28 June 2019

Alison Johnstone
Silver Fern Farms Ltd
RD2 Fairton
PO Box 30
ASHBURTON 7740

SILVER FERN FARMS TAKAPAU CONSENT RENEWALS SECTION 92 REQUEST

**FIGURE 3A : Interpolated Groundwater Elevation:
 Shallow Aquifer November 2013 (High Stage Period)**

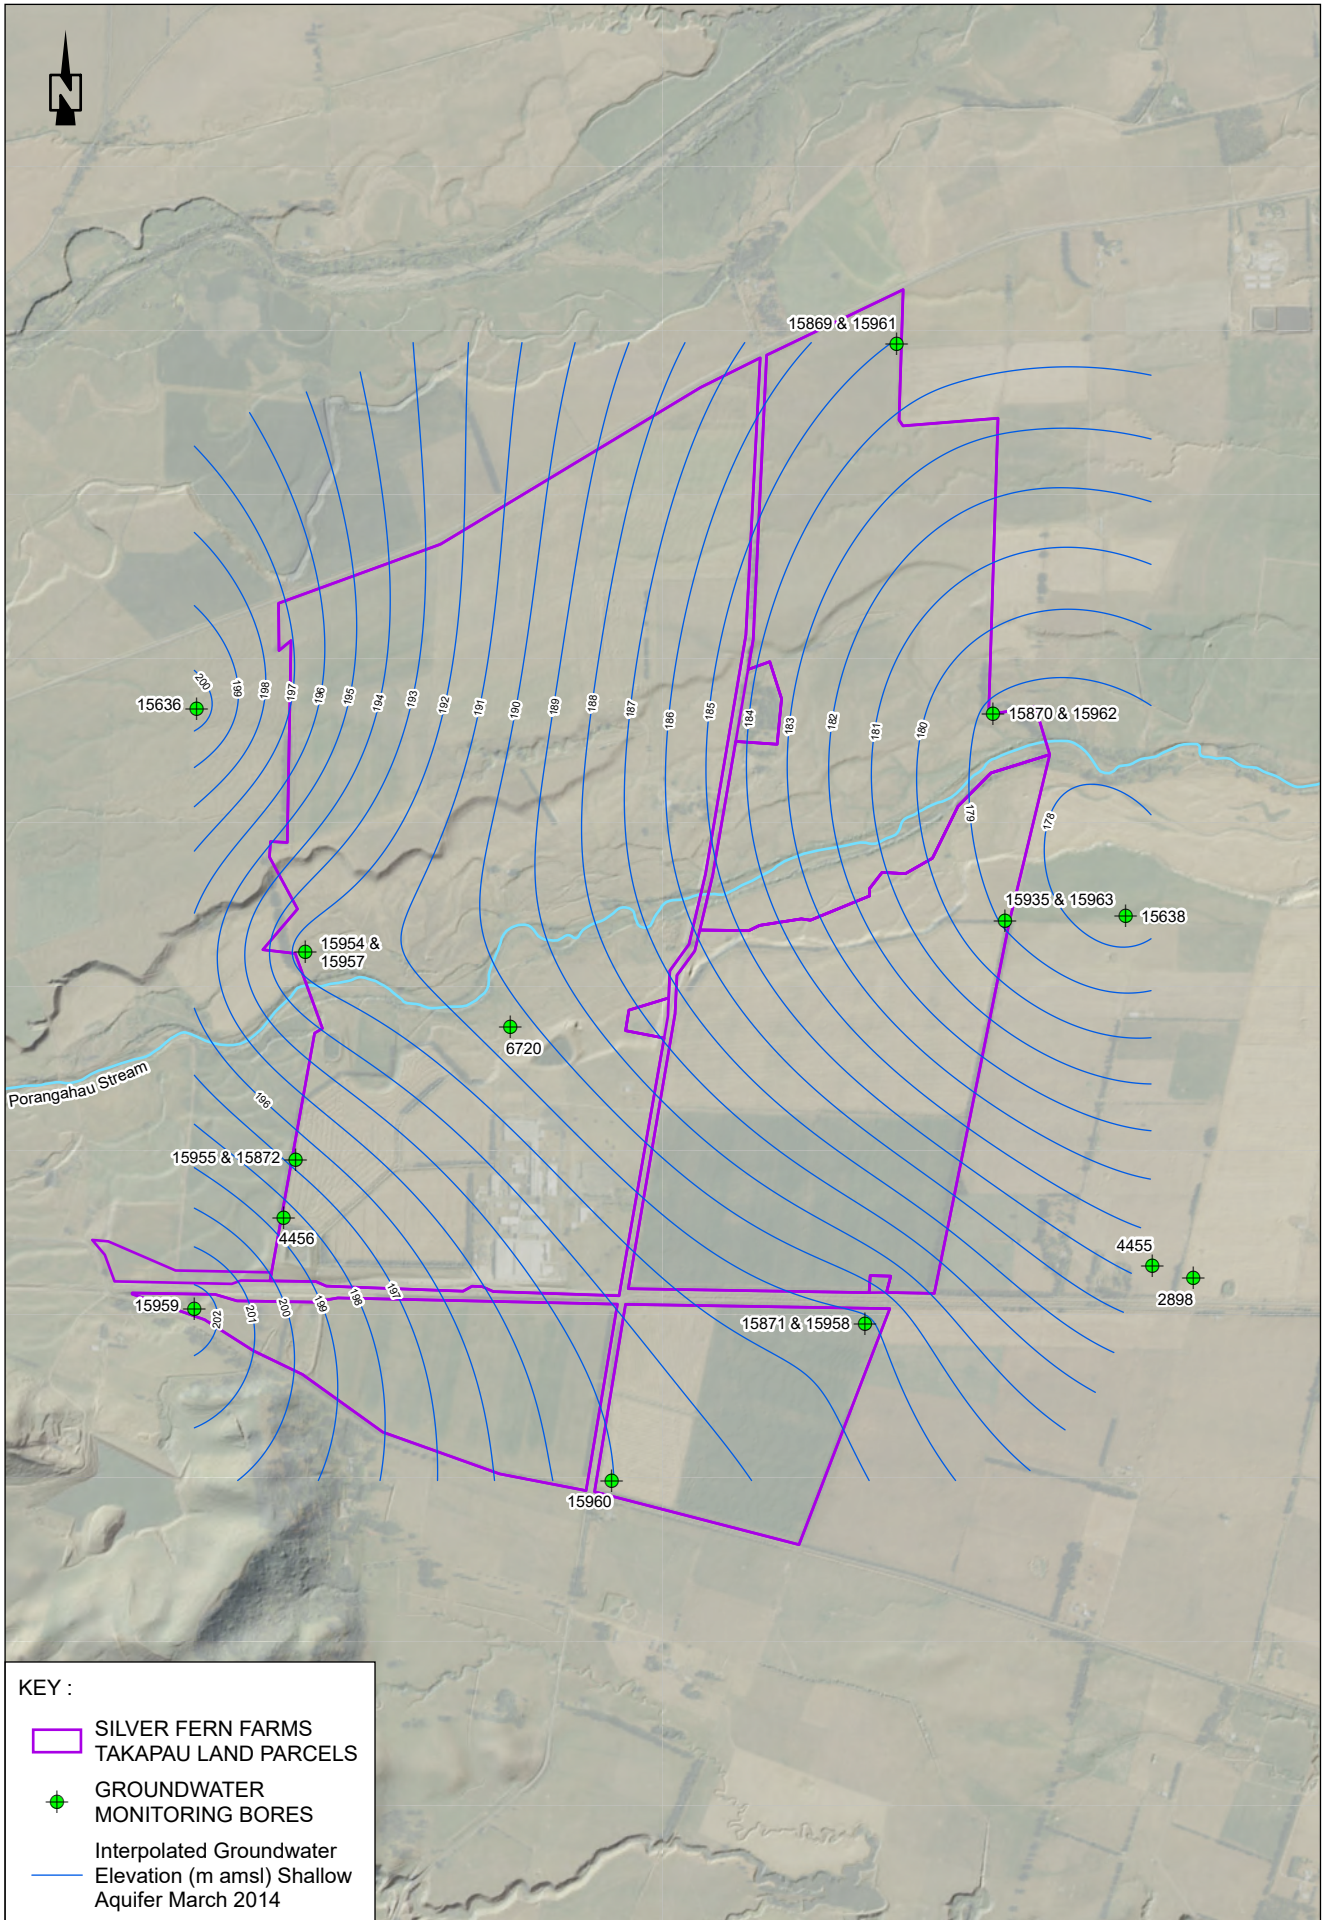
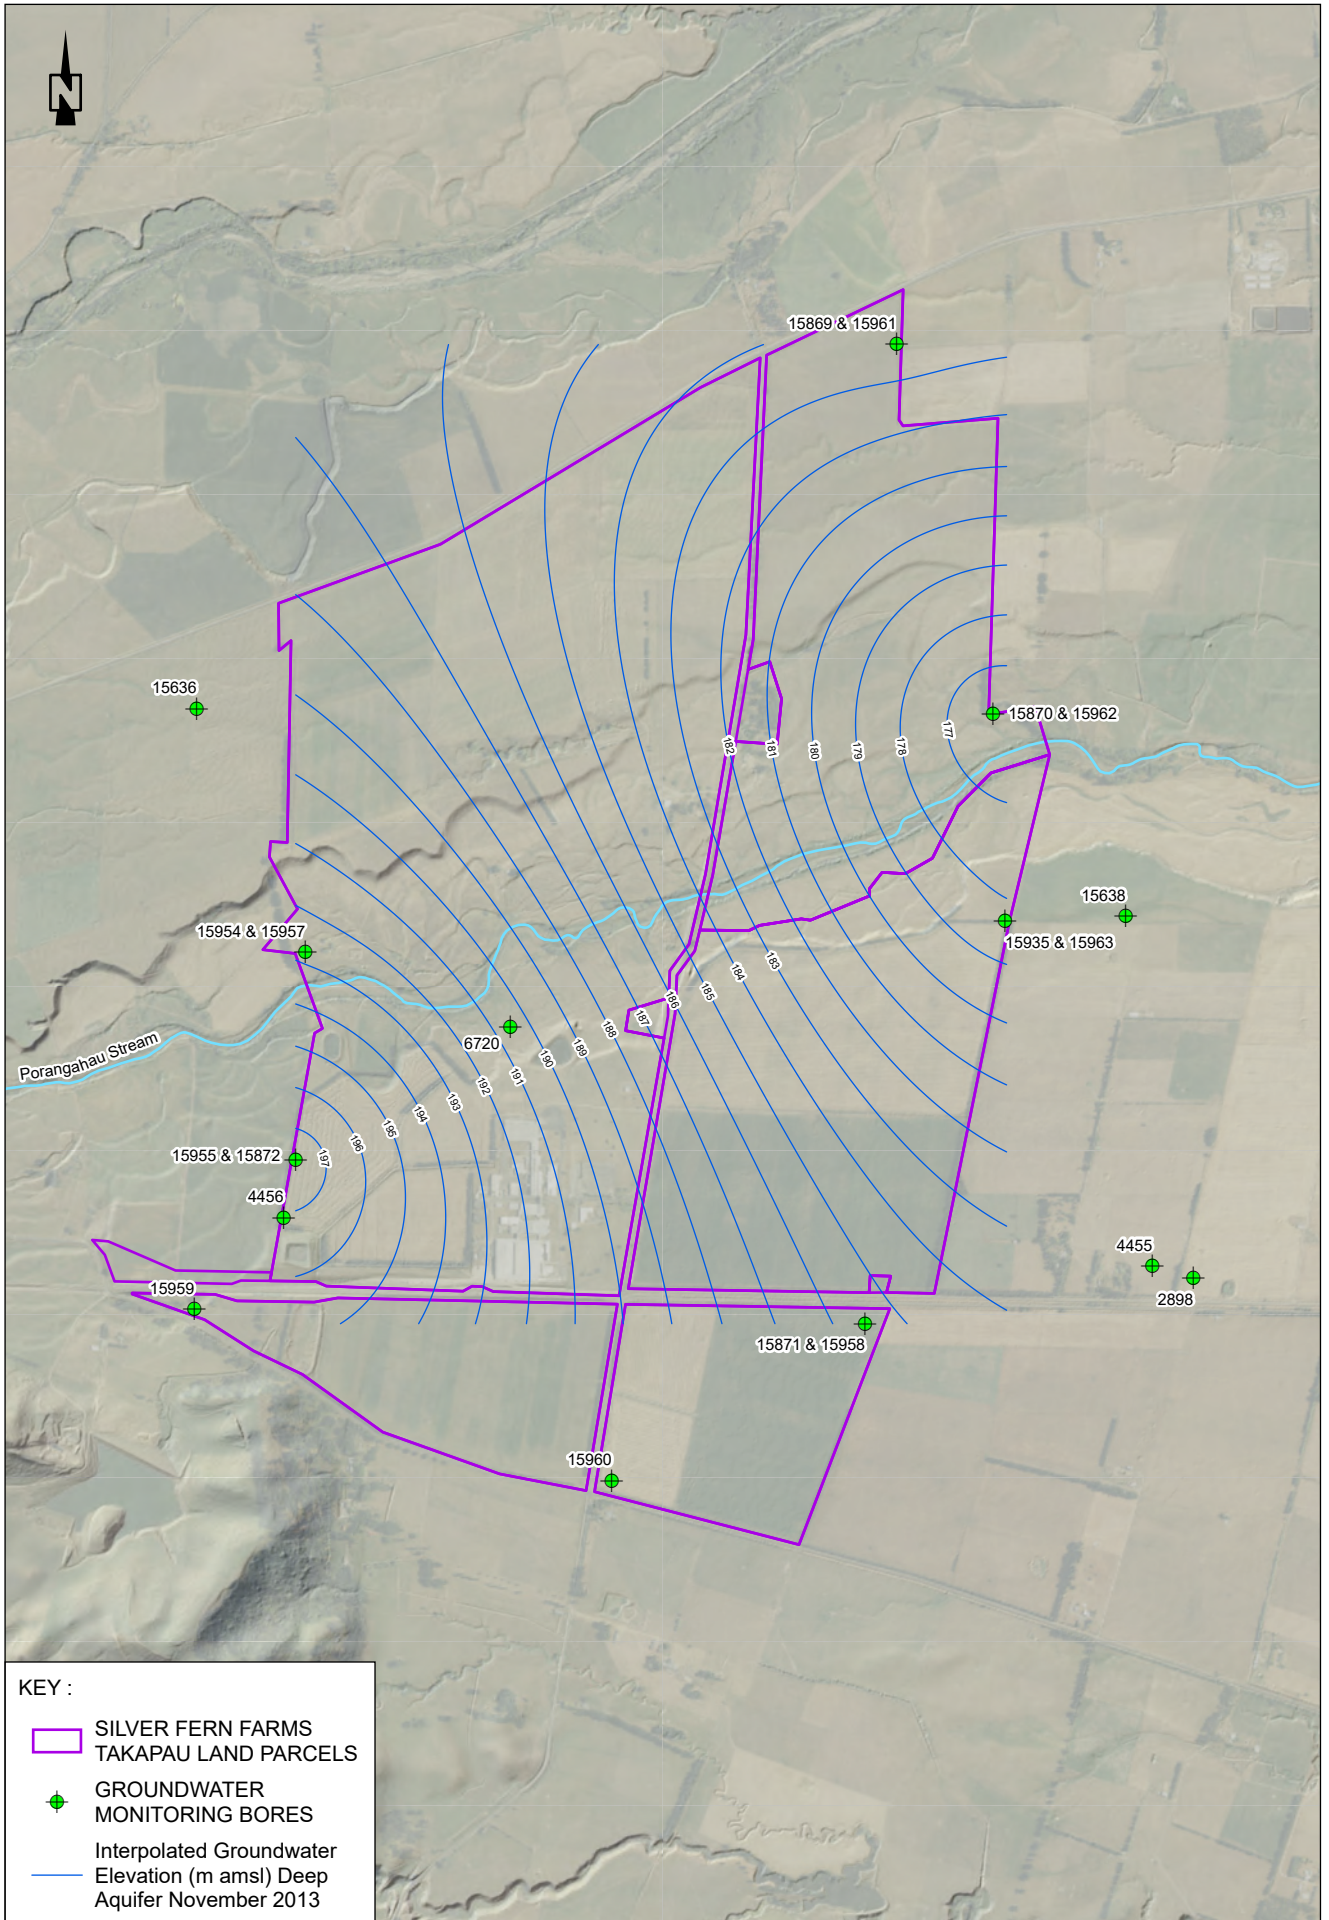
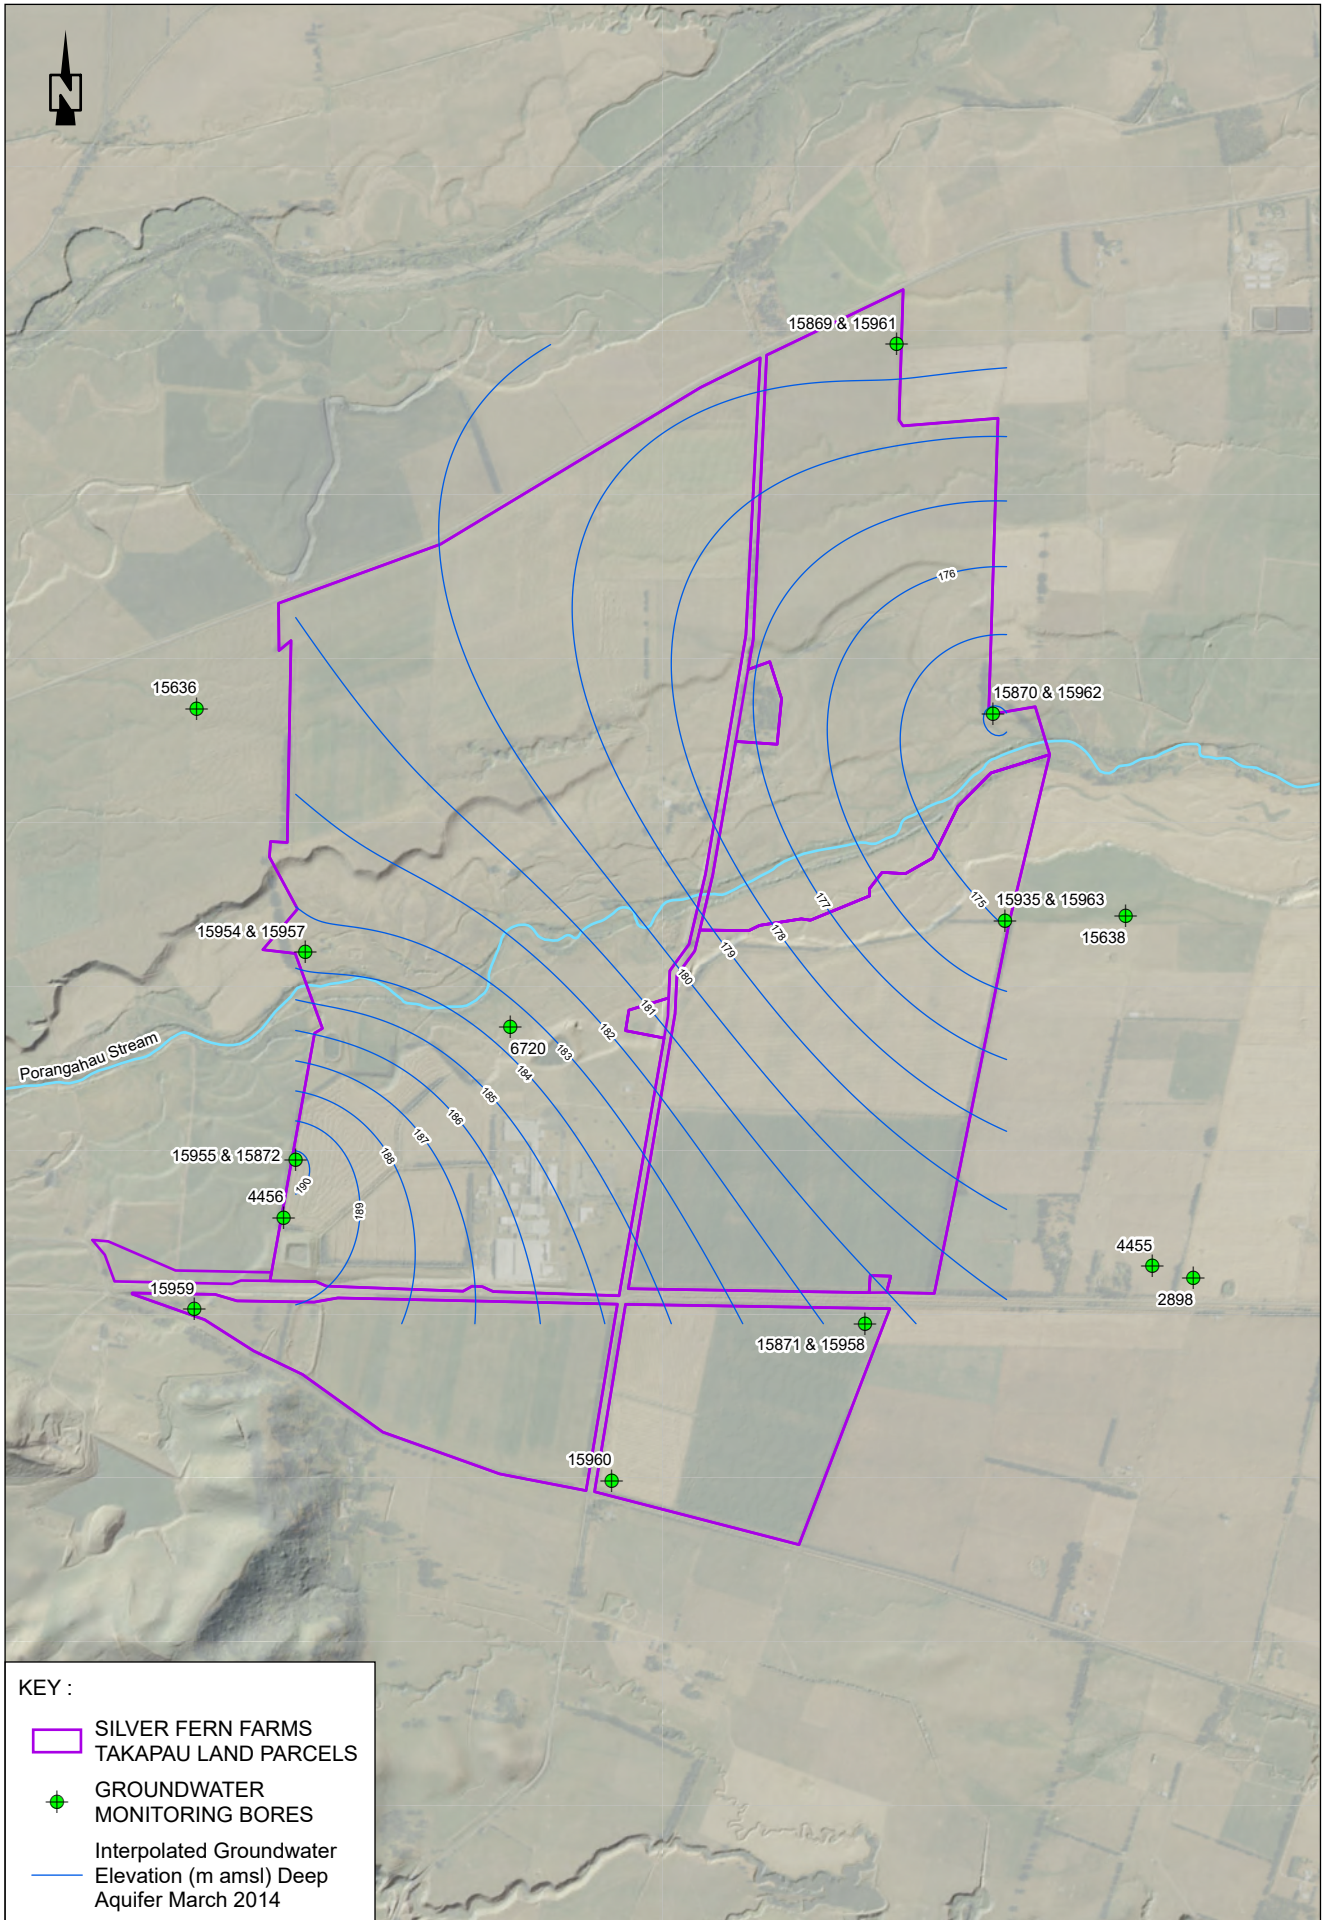
7. A map showing interpolated groundwater elevation contours in metres above mean sea level (mASML) for the shallow and deep aquifers. Provide a piezometric surface plot during high and low river stage times for the shallow and deep aquifers to assess any changes in groundwater flow direction under different climatic conditions.

The interpolated groundwater elevation contours for both shallow and deep monitoring bores for different stage conditions are shown in Figures 3a to 3d, appended. As with the other elevation contours, there is uncertainty in these, particularly away from the bores. However, the contours suggest that there are no significant changes in the general inferred groundwater flow patterns with different stream flows/stage.

Overall, the figures indicate a similar groundwater contour pattern to that presented in Figure 7 in PDP (2010), with a slightly more north-easterly direction inferred for the groundwater flow direction in the southern parts of the site.
